PCI-SIG ENGINEERING CHANGE REQUEST

TITLE:	OCuLink BP Type Rev 1.7
DATE:	January 6, 2017
AFFECTED DOCUMENT:	OCuLink Specification version 1.0
SPONSOR:	Jay Neer (Molex), Alex Haser (Molex)

Figure 2-x. Upstream/ downstream port assignment

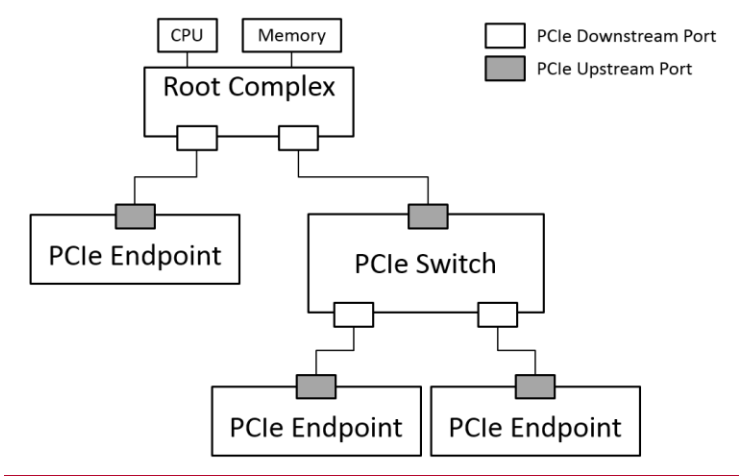
Upstream/ downstream port assignment is defined as shown in Figure 2-x below. This naming convention is consistent across all PCIe documentation. Refer to the Base Specification for more information.
